## Safety Notice

200004

**Date:** January 29, 2020  
**Models and Serial Numbers Affected:** See tables 1 and 2  
**Subject:** Turntable Rotation Bearing Bolts  
**Allowable Hours:** 2 hours

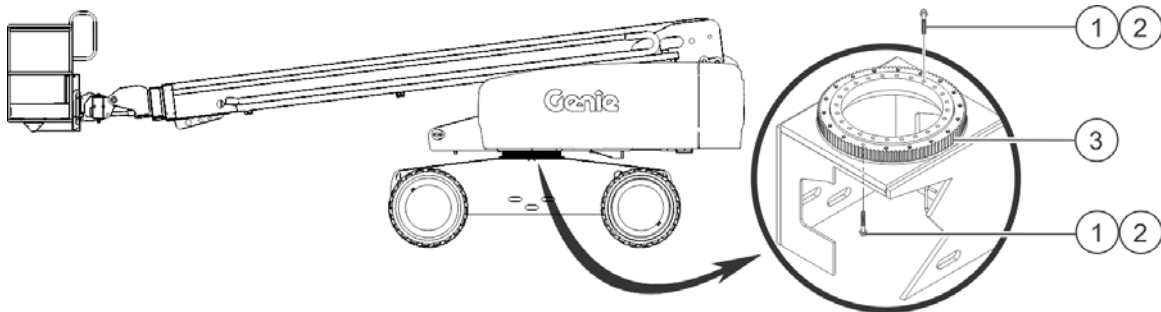
Genie has been notified of three instances where the bottom turntable rotation bearing bolts in the machines referenced above have come loose causing the separation of the turntable from the chassis. **Separation of the turntable from the chassis can result in a machine tip-over or other structural failure.**

- 1 Bolts, PN 1256170GT
- 2 Washer, PN 1256182
- 3 Turntable rotation bearing

- 1 Locate the affected machines referenced above within your fleet.
- 2 **Machines with a year of manufacture 2019 up to the release date of this notice (see Table 1):**
  - Remove the machine from service.
  - Following the instructions starting on page 3, confirm that each turntable bearing bolt is torqued to specification.

- As soon as possible but no later than 30 days from receipt of this notice and following the instructions starting on page 3, confirm that each turntable bearing bolt is torqued to specification.
- 3 Return the machine to service.
  - 4 Fill out and sign the attached completion form and return to Terex AWP Warranty Department or file a warranty claim online to verify that this Safety Notice has been completed.

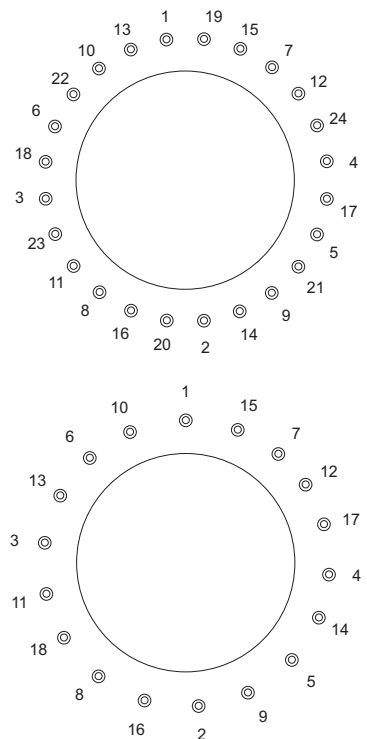
Crushing hazard. Keep hands away from the cylinder and all moving parts when lowering the boom.

- 1 Raise the (primary) boom and place a safety chock on the lift cylinder rod. Carefully lower the boom until it is 1 inch / 2,5 cm from the lift cylinder safety chock OR support the boom assembly with a suitable lifting device.
- 2 Turn the key switch to the off position.
- 3 Using a star pattern, confirm that each upper turntable rotation bearing bolt (24 X) is torqued in sequence to the specification.

**Torque Specification = 180 ft-lbs / 244 Nm**

- 4 Raise the boom and remove the safety chock OR lifting device.
- 5 Lower the boom to the stowed position.
- 6 Using a star pattern, confirm that each lower turntable rotation bearing bolt (18 X) is torqued in sequence to the specification.
- 7 **Torque Specification = 180 ft-lbs / 244 Nm**
